## Product Change Notification

### PCN-IFC-657-2017

Business Unit	Product Line Code	Type of Change	Action	Date of Issue
IFC - Industrial Field Connectivity	BF7	Product Change Notification	Notify Distributors and Field	5/31/2017

#### Description for Product Change Notification

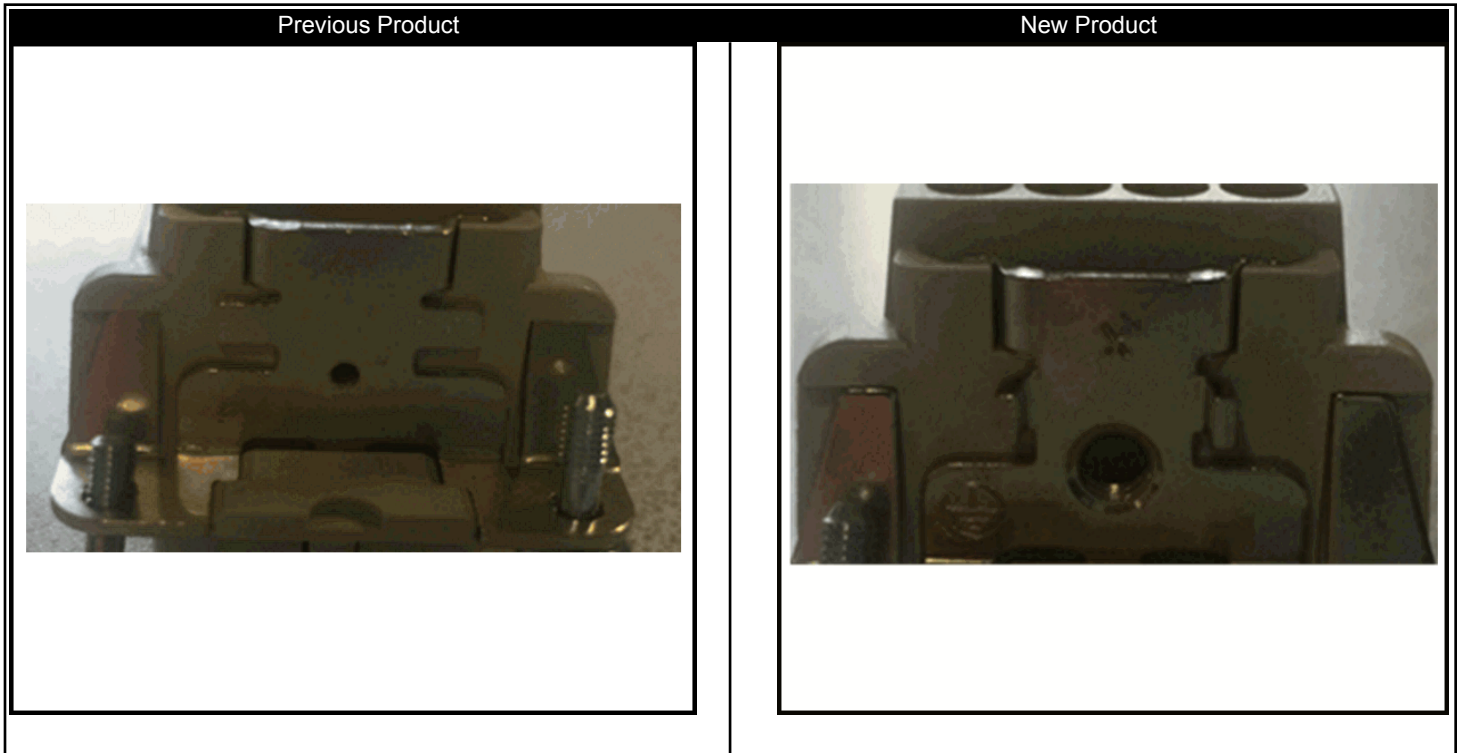
A second threaded hole has been added to the opposite end of these contact inserts. This allows for the convenience of moving the PE screw to the opposite end of the insert, or a second screw can be added if desired.
